COMMUNITY DEVELOPMENT DEPARTMENT REPORT

SUBJECT: FP-2025-0028
PAW Subdivision

LOCATION: 1680 W. Ustick Road
Located in the SE ¼ of the SE ¼ of
Section 35 T. 4N, R.1W, Parcel No.
S0435449705

D. Final Plat (date: 10/17/2025)

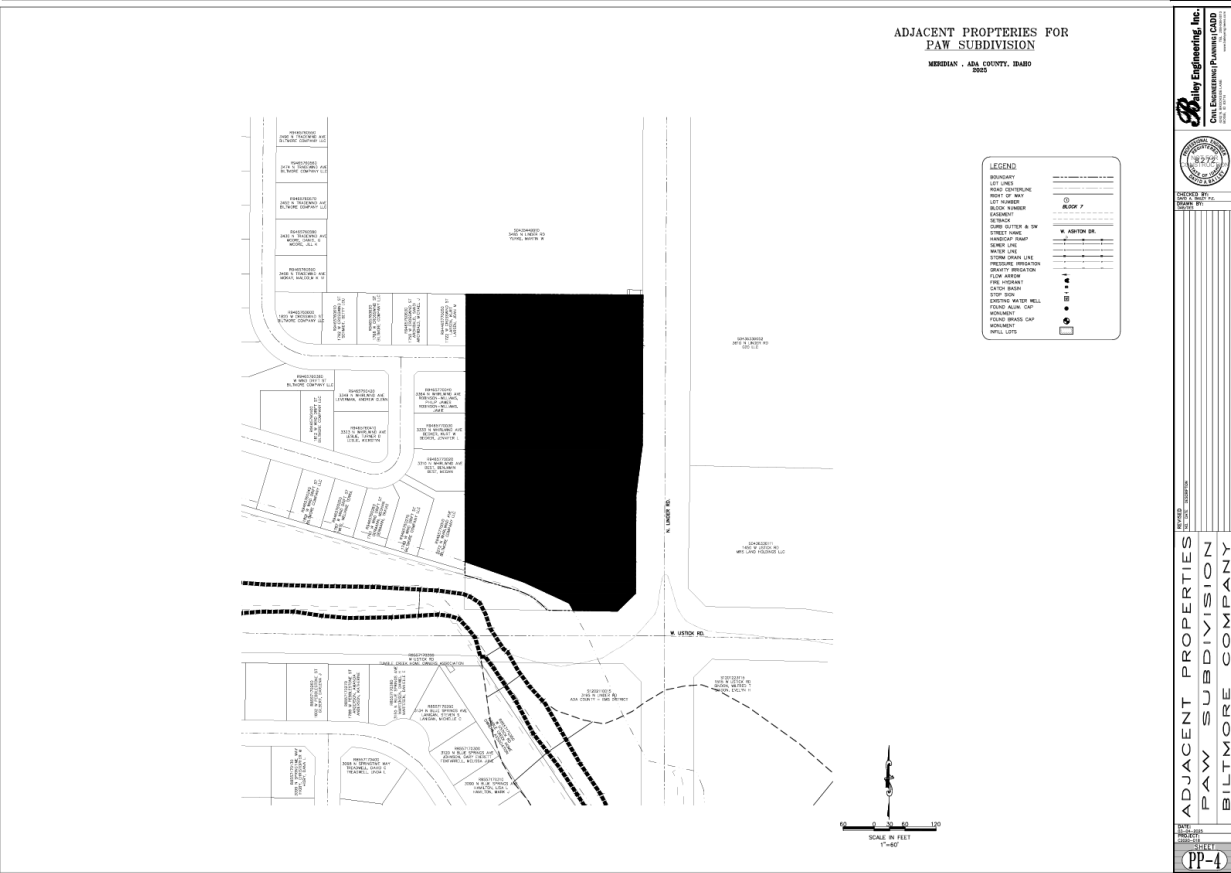
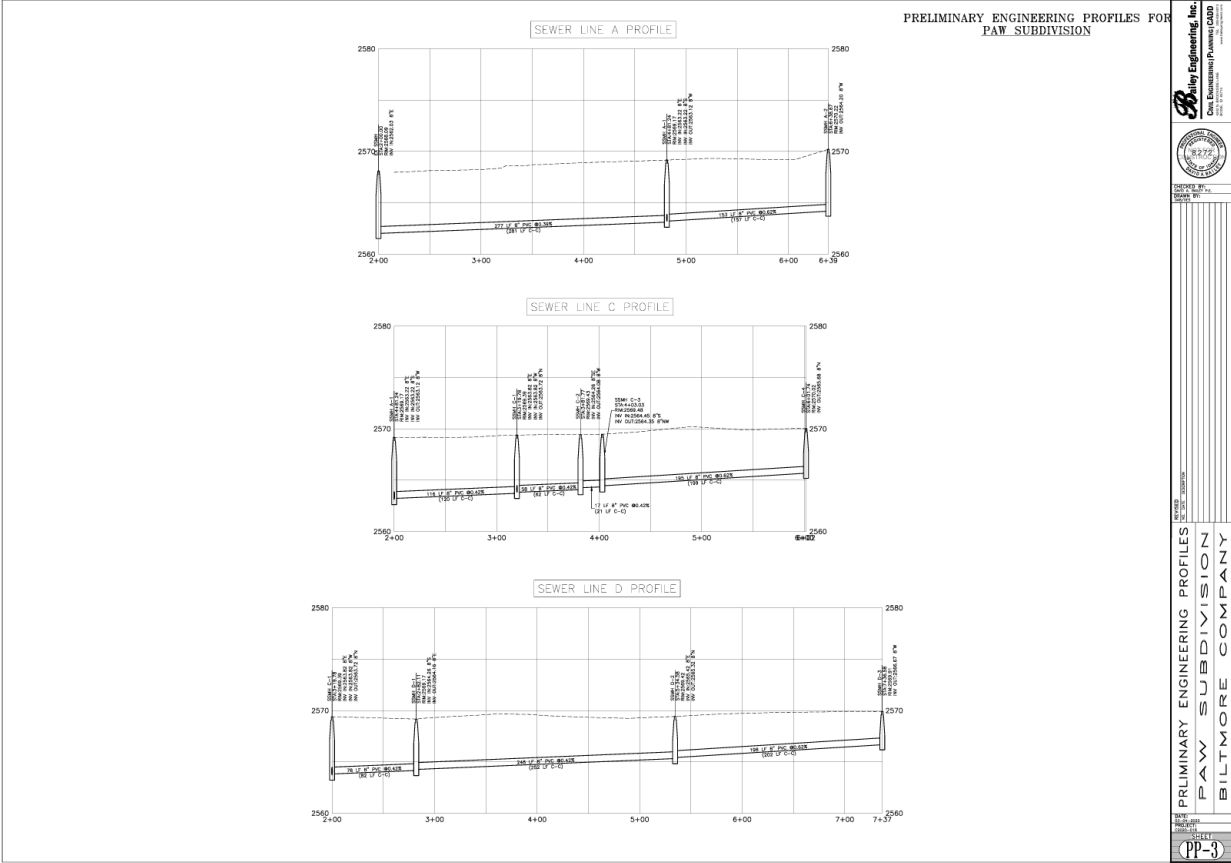
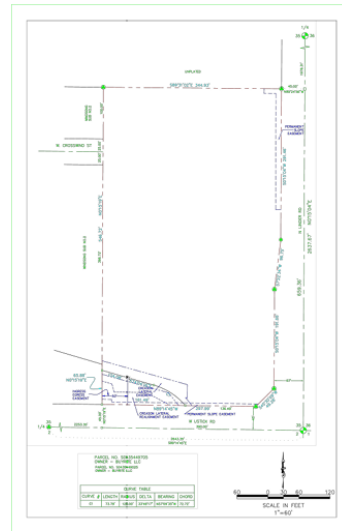
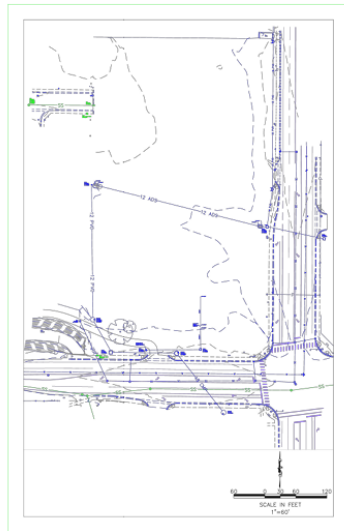
- a. Note #14: Include the instrument number for the Sanitary Sewer and Water Easement to the City of Meridian.
 - b. Remove Notes #15 and 23 as Lots 5, Block 1 and Lot 8 Block 2 are common lots not private roads.

- c. Note #16: Add who is responsible for the maintenance and operation of the private road ingress-egress and emergency access easement.
 - d. Note #17: Include the instrument number for the ACHD license agreement.

- e. Note #18: Include the instrument number for the Meridian Development agreement.
 - f. Note #19: Include the instrument number for the City of Meridian sidewalk easement.

- g. Graphically depict the zero lot lines on the plat map.
3. The Landscape Plan prepared by Stack Rock Group, dated April 21, 2026, and signed by Willet C. Howard shall be revised as follows:

5. All common lots and streets shall meet the requirements of UDC 11-6C-3.
6. No building permits shall be submitted until the final plat is recorded.
7. The final plat shown in Section VI.G, prepared by Bailey Engineering, Inc., stamped on 2/3/2025 by Clinton W. Hansen, shall be revised prior to signature on the final plat by the City Engineer, as follows:

F. Landscape Plan (date: 4/21/2026)

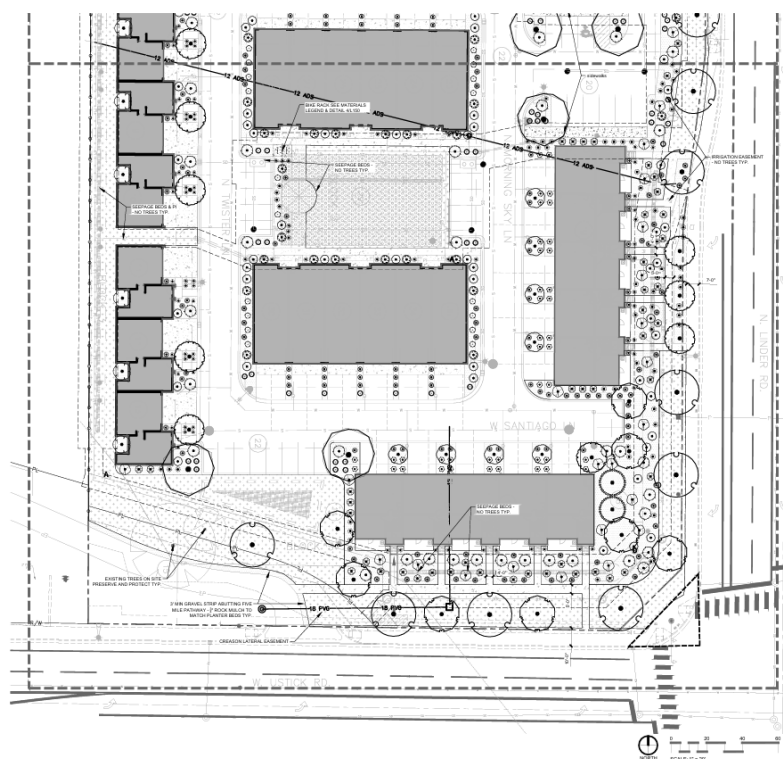
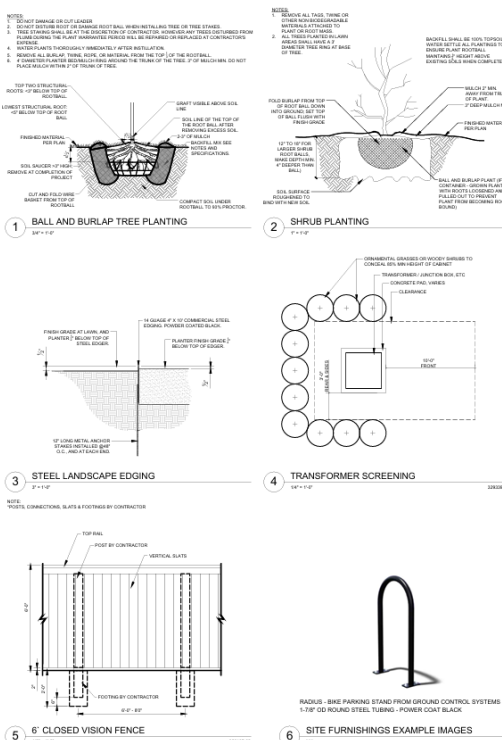
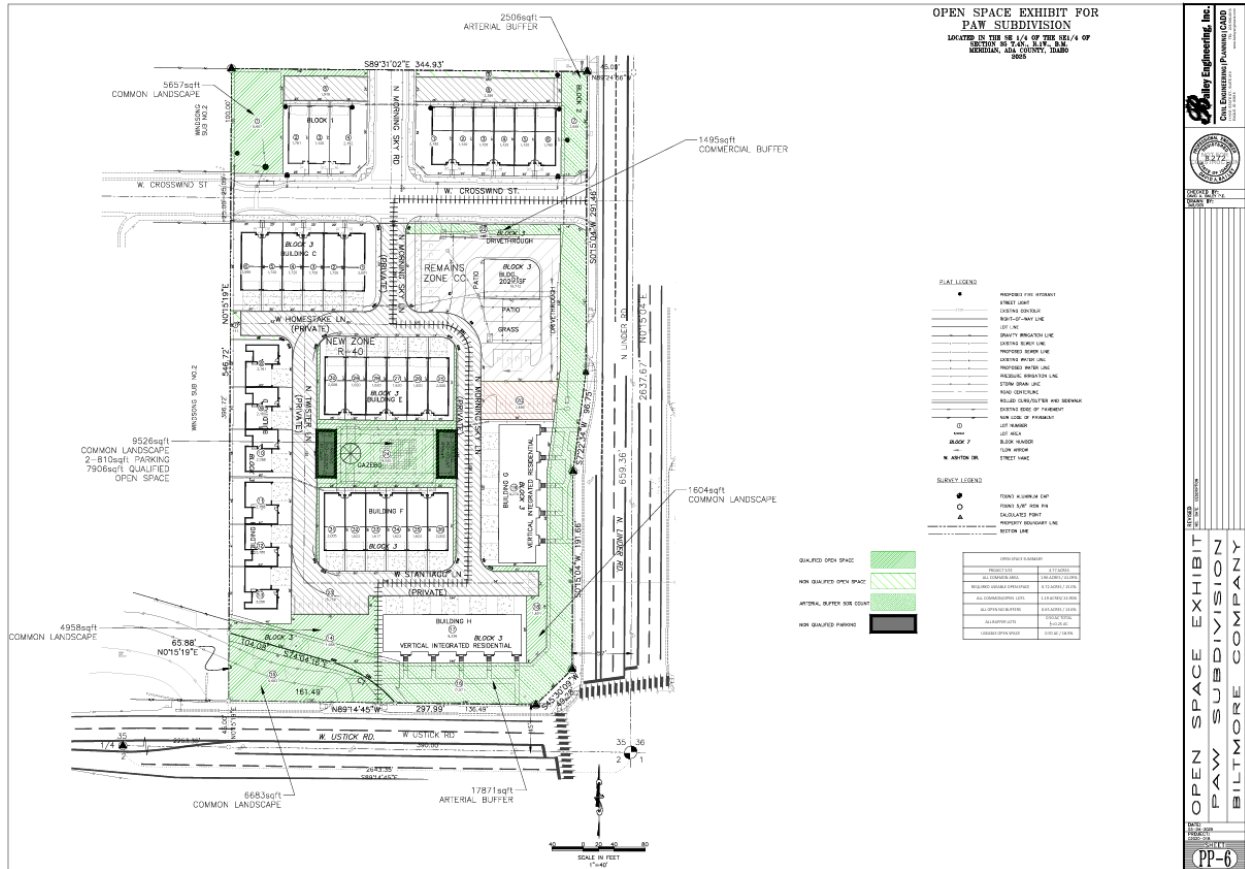
- a. Show the full width of the required pathway along N. Linder Road.
 - b. Call out the width of the landscape buffers along Linder Road and Ustick Road.
